Access Compliance Report

Public Rights-of-Way

(Curb Ramps)

Intersection ID: 4999	Main Street: E_MALLARD_CREEK_CHURCH_RD	Cross Street: STONE_QUARRY_RD	Location: W
ADA ID: 3E83A3D0A999	Ramp Type: Perp	Initial Pass/Fail: Fail	Overall Compliance: No
Severity Score: 22.5			
Codes/Mitigation Info/Possible Solution		Field Measurements/Component Compliance

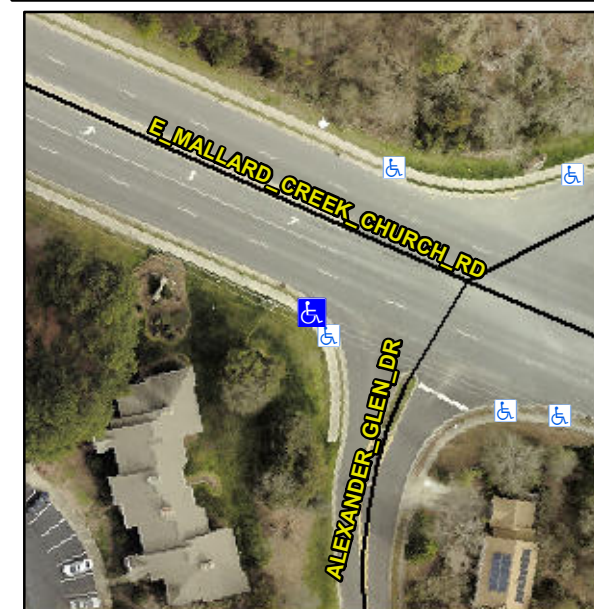
R304.5.1, R304.2.2

Compliance	Description	Data	Compliance	Description	Data
N/A	Ramp Length (in)	69.0	No	Ramp Slope (%)	10.1
No	Ramp Width (in)	47.0	Yes	Ramp XSlope (%)	2.2
N/A	Flare Type LT	N/A	N/A	Flare Type RT	N/A
N/A	Flare Slope LT (%)	N/A	N/A	Flare Slope RT (%)	N/A
N/A	Flare Traversable LT?	N/A	N/A	Flare Traversable RT?	N/A
N/A	Landing Length (in)	N/A	N/A	DWS Provided?	N/A
N/A	Landing Width (in)	N/A	N/A	DWS Contrast?	N/A
N/A	Landing Slope (%)	N/A	N/A	DWS Length (in)	N/A
N/A	Landing X Slope (%)	N/A	N/A	DWS Full Width?	N/A
N/A	Landing Curb? (Y/N)	N/A	N/A	DWS Offset (in)	N/A
N/A	Shared Landing?	N/A			
N/A	Gutter Ponding?	N/A	N/A	Gutter Slope (%)	N/A
N/A	Gutter Lip Ht (in)	N/A	N/A	Gutter X Slope (%)	N/A
N/A	Painted X Walk1?	No	N/A	Painted X Walk2?	N/A
	X Walk 1 Direction	To NE		X Walk 2 Direction	N/A
N/A	X Walk 1 Width (in)	N/A	N/A	X Walk 2 Width (in)	N/A
	X Walk 1 Slope (%)	4.1		X Walk 2 Slope (%)	N/A
	X Walk 1 X Slope (%)	7.6		X Walk 2 X Slope (%)	N/A

Remove & Replace Entire Ramp.
